CROSSROADS MIXED USE FILING NO. 1

COUNTY OF EL PASO, STATE OF COLORADO STORM SEWER PLANS

UNDERGROUND DETENTION

MARCH 2023

STORM 4.1B (PRIVATE)
STA 1+00.00 TO STA 2+46.92

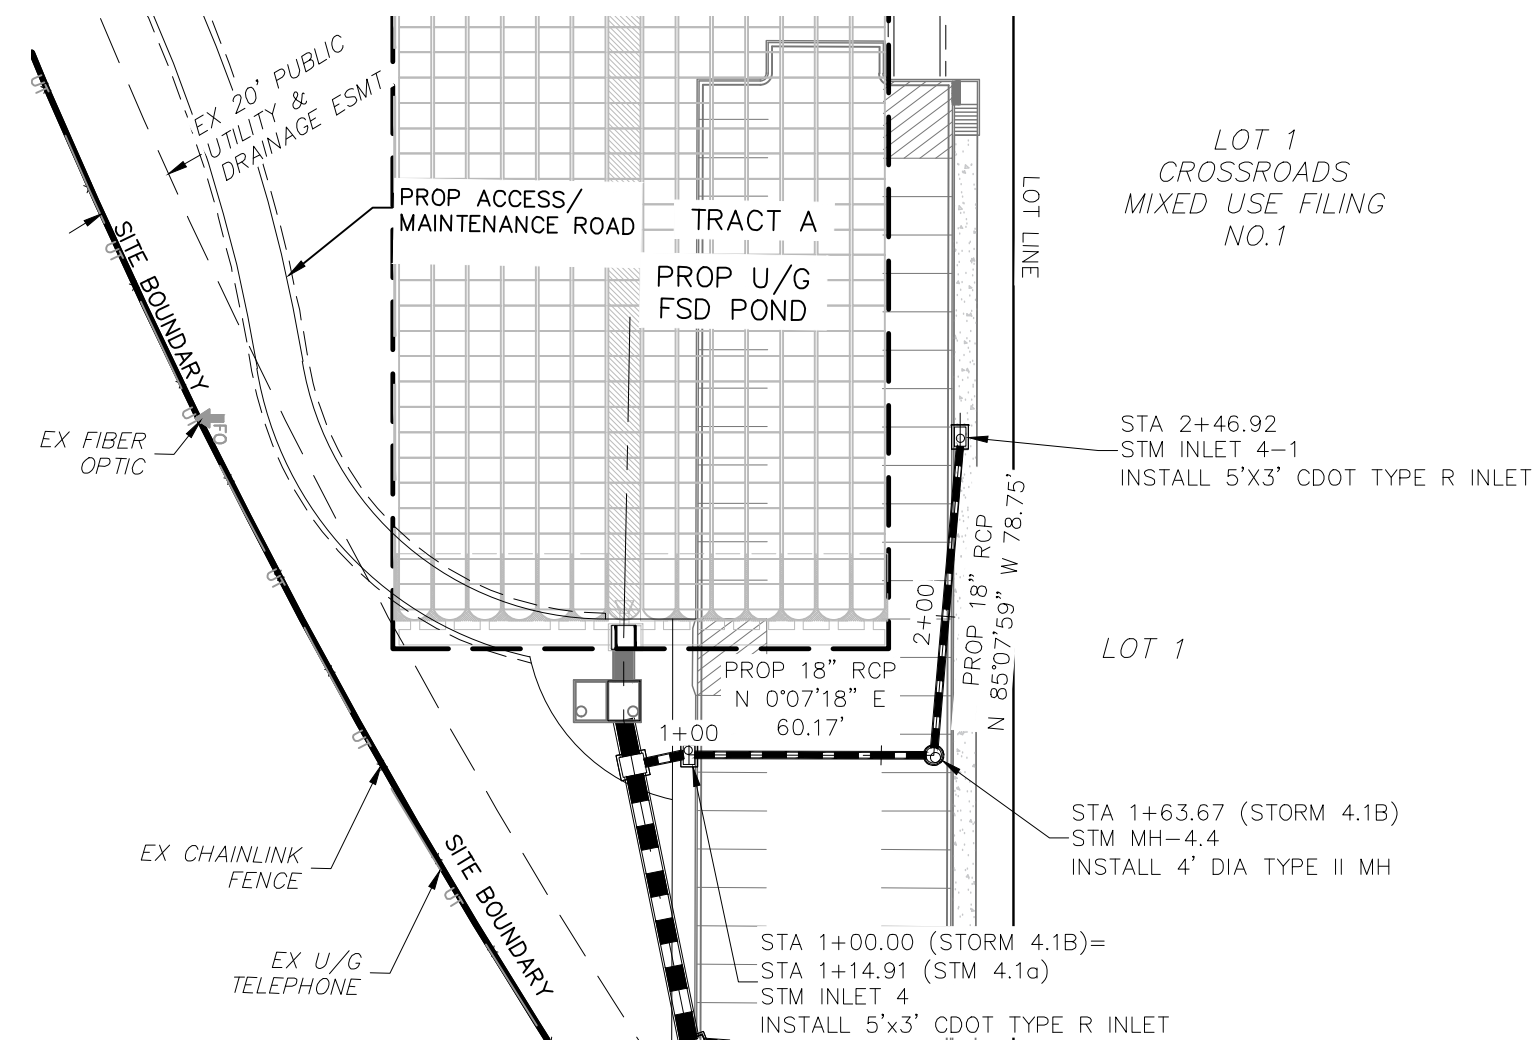
Update callout. Sheet ST06 identifies this as MH-5.1

TIER 1 DEEP COVER SPECIAL PROVISIONS

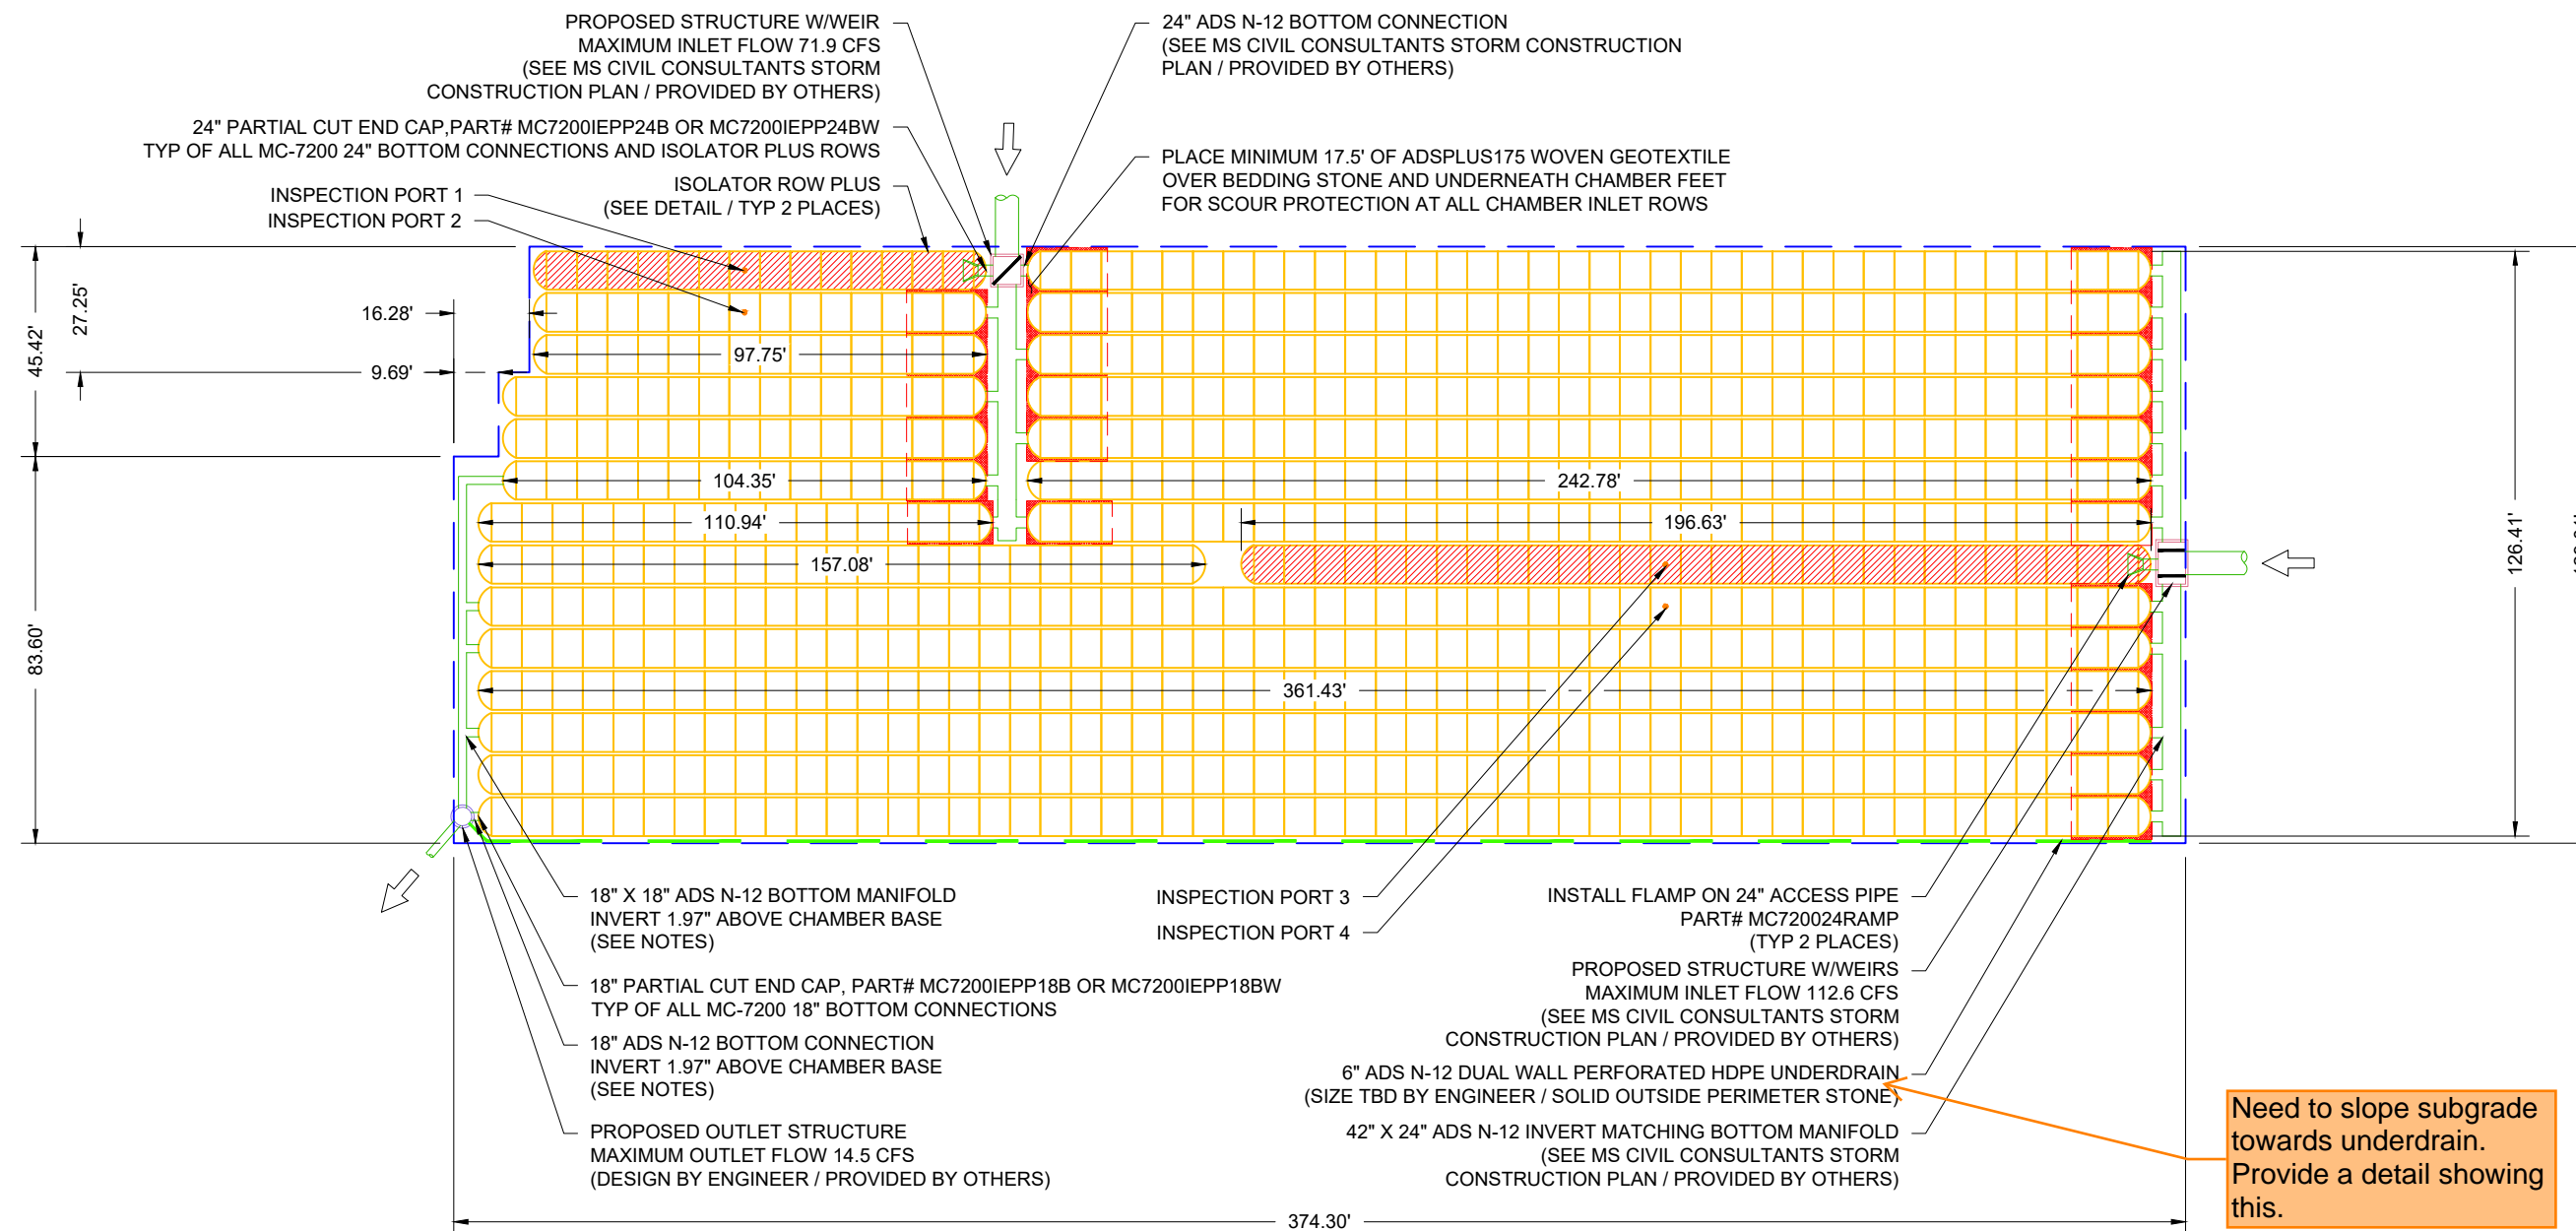
A site specific detail like this is needed to show elevation of "floor" of rows. I don't see this elevation elsewhere in the M&S planset above.

SYSTEM BS-2	NORTHSIDE
WQ FLOW RATE (CFS)	11.9
PEAK FLOW RATE (CFS)	71.9
INLET PIPE	48" RCP
INLET INVERT	6288.72
OUTLET PIPE	48" RCP
OUTLET INVERT	6288.22
RIM ELEVATION	6296.78
WIDTH (FT)	8'
LENGTH (FT)	8'
INSIDE HEIGHT (FT)	16'

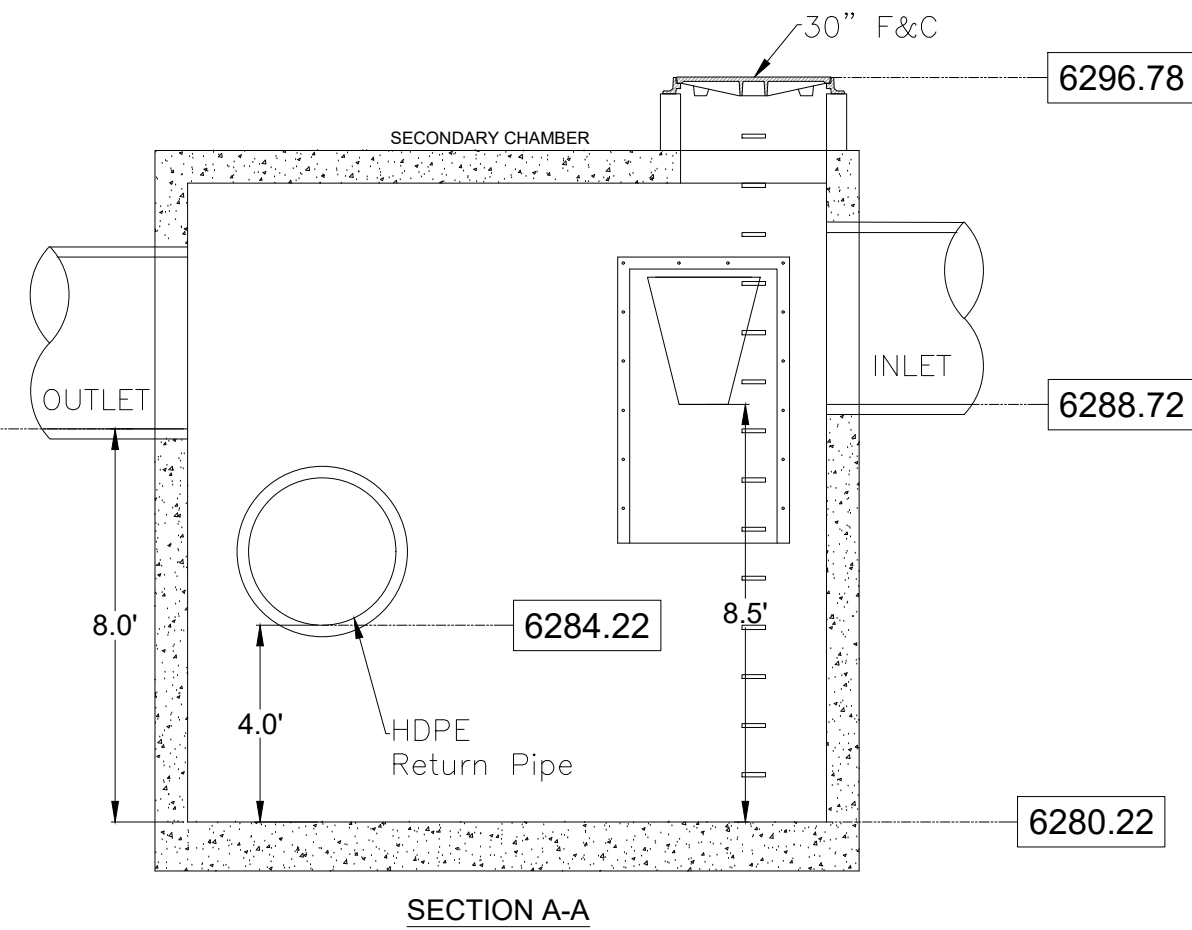
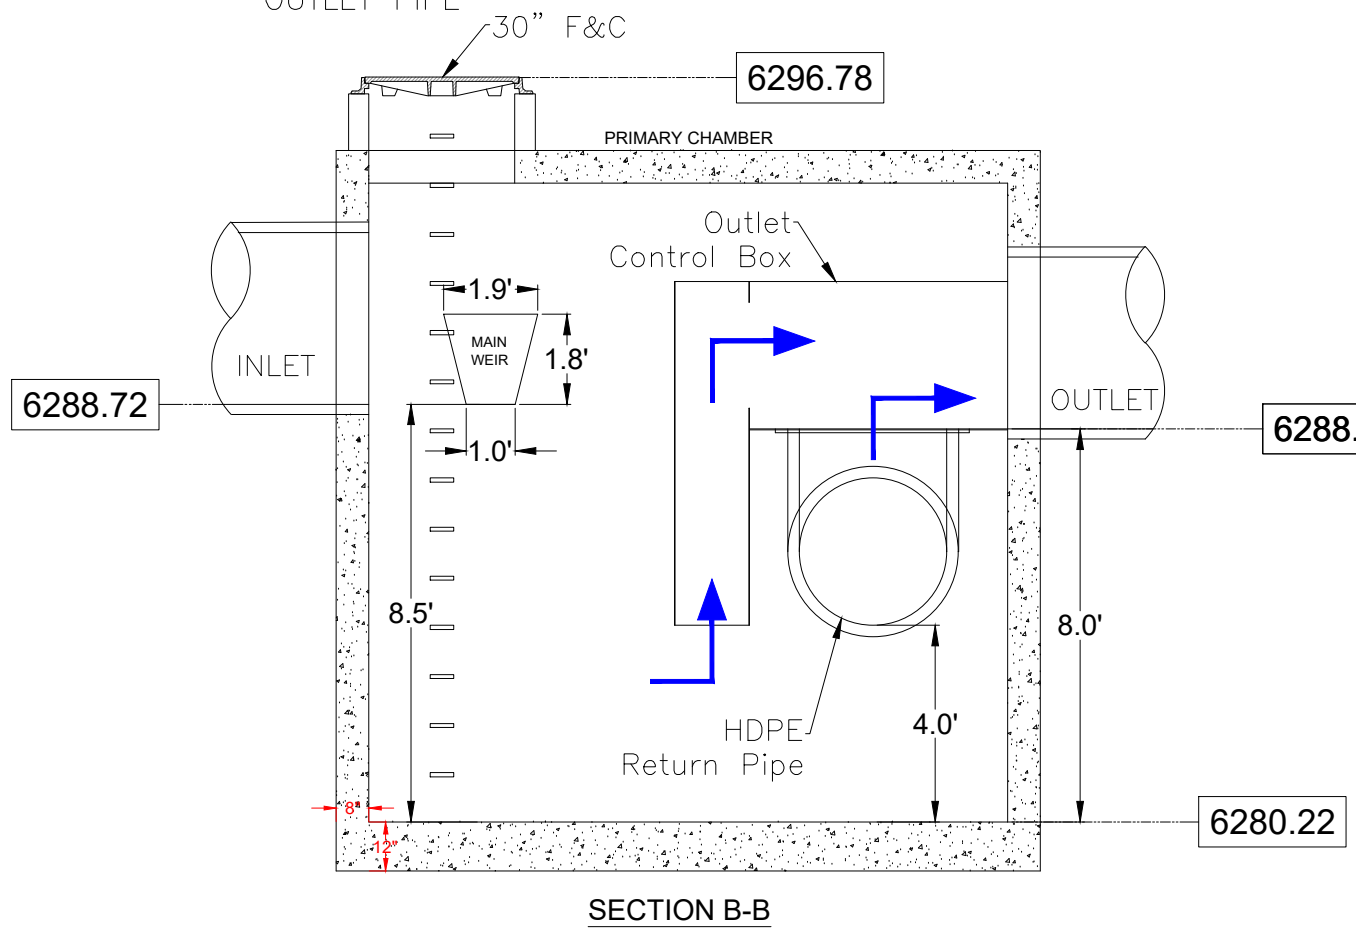
Clarify if this is peak inflow or capacity. If not capacity, add a row for peak capacity so it is clearly shown that this structure has a capacity to handle the peak inflow

SYSTEM BS-1	EASTSIDE
WQ FLOW RATE (CFS)	25.4
PEAK FLOW RATE (CFS)	112.6
INLET PIPE	54" RCP
INLET INVERT	6288.72
OUTLET PIPE	54" RCP
OUTLET INVERT	6288.22
RIM ELEVATION	6297.80
WIDTH (FT)	8'
LENGTH (FT)	16'
INSIDE HEIGHT (FT)	16'

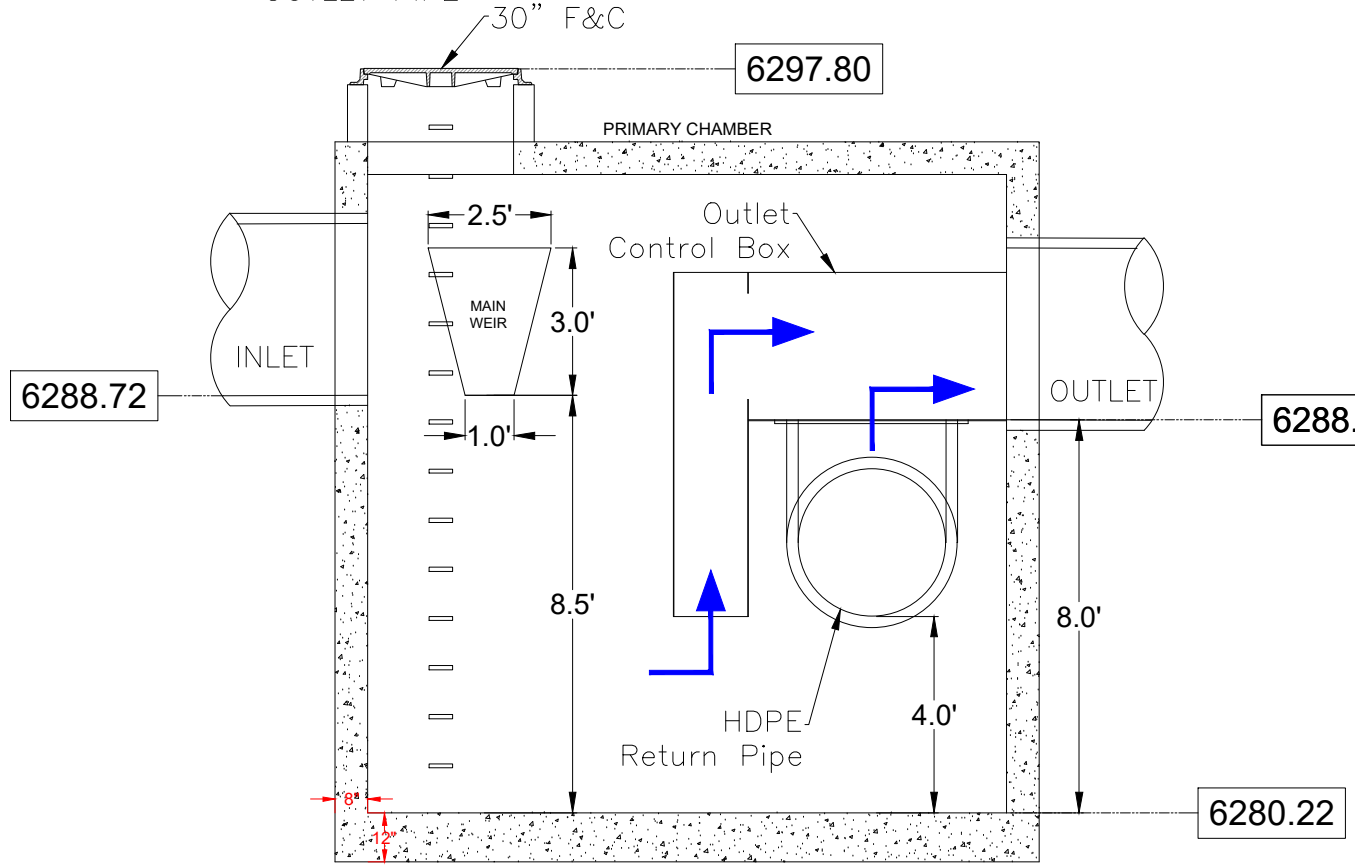
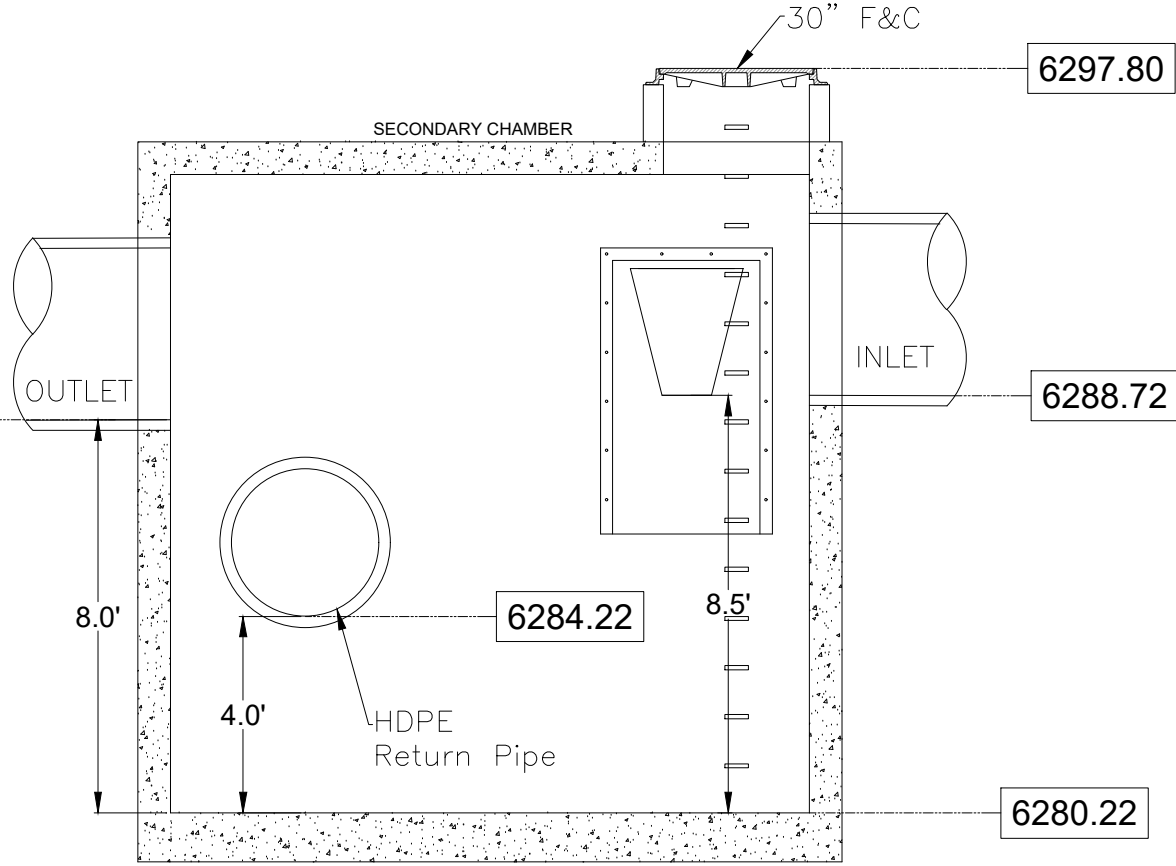
Clarify if this is peak inflow or capacity. If not capacity, add a row for peak capacity so it is clearly shown that this structure has a capacity to handle the peak inflow
